Comment on Eversource 1/18/2024 Hurd State Park Asset Condition project:

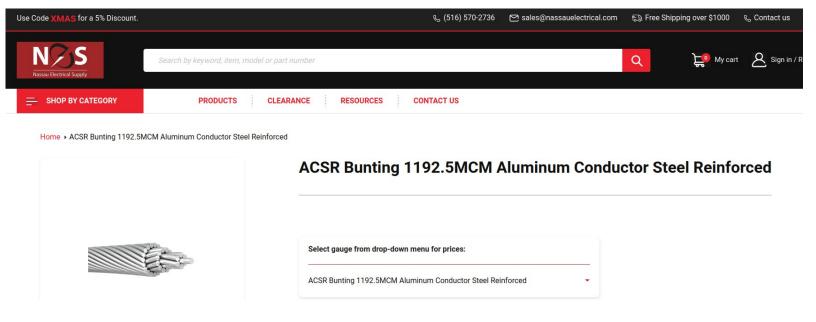
- The 362, 376, 1772 lines use 1192 ACSR conductor for the spans crossing the Connecticut River
 - This conductor is custom-made and no longer readily available
 - On a similar river crossing span on the 1772 and 348 lines where the 1192 ACSR was utilized, damage caused by vibration was observed in 2020

Is this conductor 1192, and if so, why was it custom-made when 1192.5 conductor was presumably available?

Or is it 1192.5, and if so, is it no longer readily available?

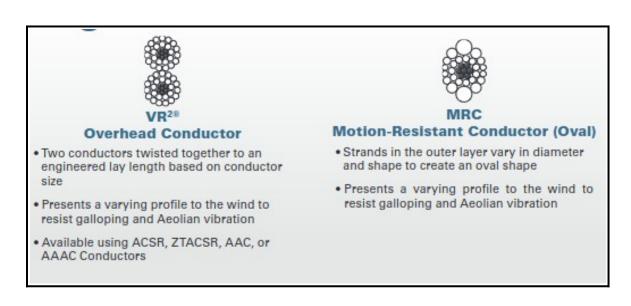
On a similar river crossing span...where the 1192 was utilized, damage caused by vibration was observed in 2020."

(Why utilized rather than used? "utilize is typically applied with the particular meaning of "to make use of: to turn to practical use or account," and often suggests the discovery of a new, profitable, or practical use for something...")

Where the 1192 was used, damage caused by vibration was observed in 2020.

Where Eversource installed the 1192 on a similar river crossing, aeolian vibration damaged the conductor.

Eversource installed 1192.5 ASCR conductor on a similar river crossing in 19XX Routine drone inspections XX years later showed minor damage to XX conductor due to aeolian vibration. This damage was repaired.
